~~October 9, 2024~~ October 10, 2024

**Addendum 1:
Bid Clarifications and Responses to
Bidder Requests for Information (pre-Bid RFIs)**

**Sebago Lake State Park
Bathhouses (2), Pole Barn, Entrance Booth, & Amphitheater Upgrades
BGS project number: 3637**

WALL SECTION

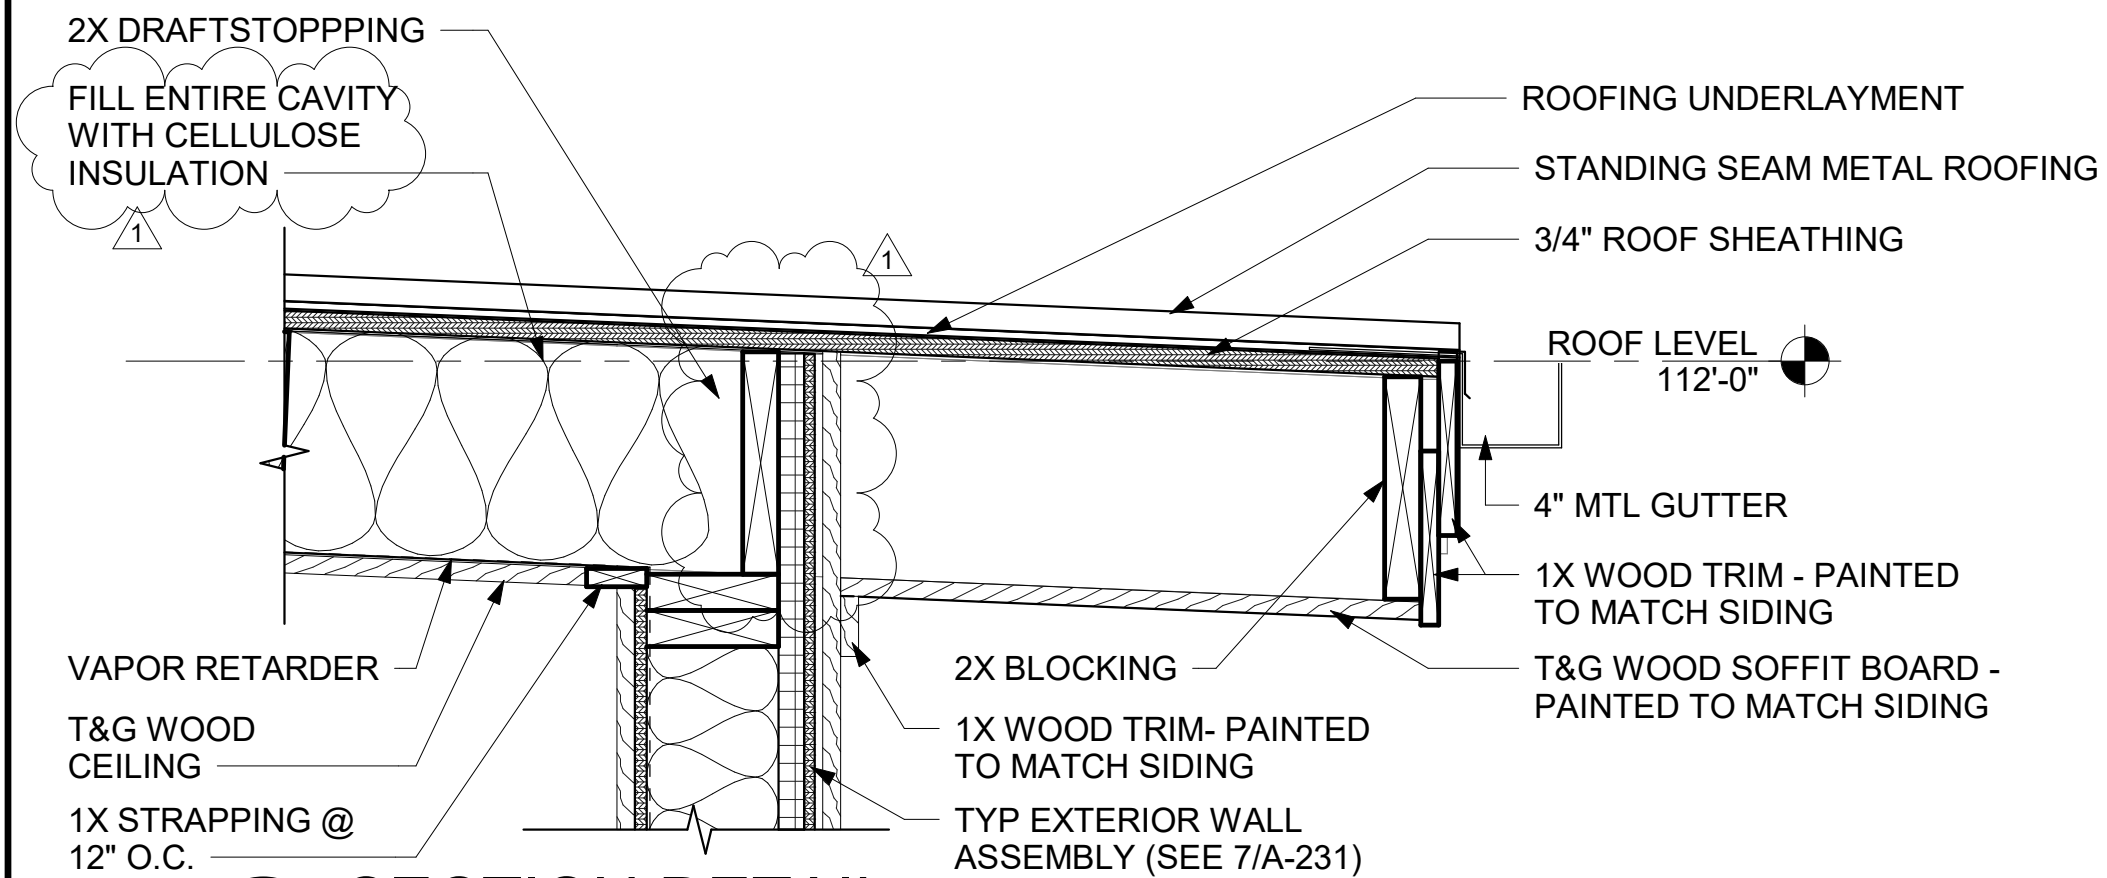
RFI 2: Entrance Booth - We would...typically avoid installing R-29 Densepack in an unvented Roof Cavity (unless you plan to vent it above the sheathing). This configuration is an invitation for moisture issues and does not meet code. I also don't understand why they are bothering to specify the R-6 Continuous at the outside of the Exterior Walls when not insulating the roof to code.

Response: See attached updated details. The bid set documents are code compliant per the relevant codes and their applicability for the Entrance Booth Project.

REPLACES SECTION 7/A-231

KS-1

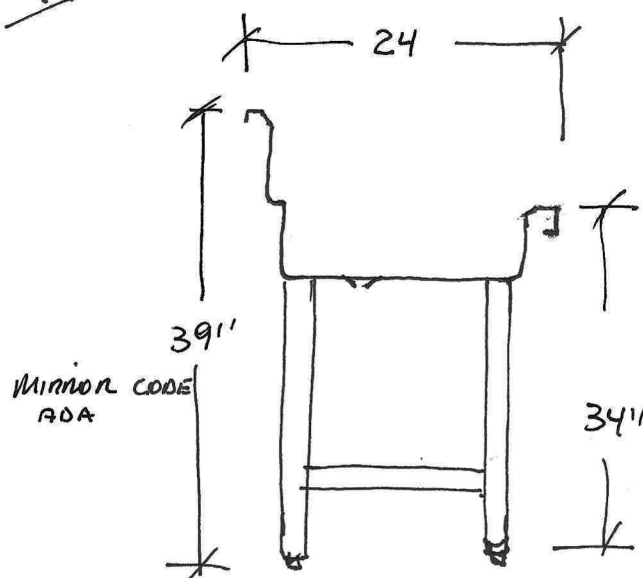
RFI 10: Are there any details on dishwashing stations? Countertop type? Brackets?

RFI 11: The sink is labeled for dishwashing but it doesn't call out anything for what the countertop is and how its built?

Response: The requirements for the exterior sinks are per the plumbing fixture schedule on drawing P-601; refer to tags KS-1, and KS-1A.

Response: The countertop is integral to the sink/backsplash and constructed of stainless steel; refer to the attached sketches for basis-of-design information; contractor is to submit shop drawings for review and approval by the owner and engineer.
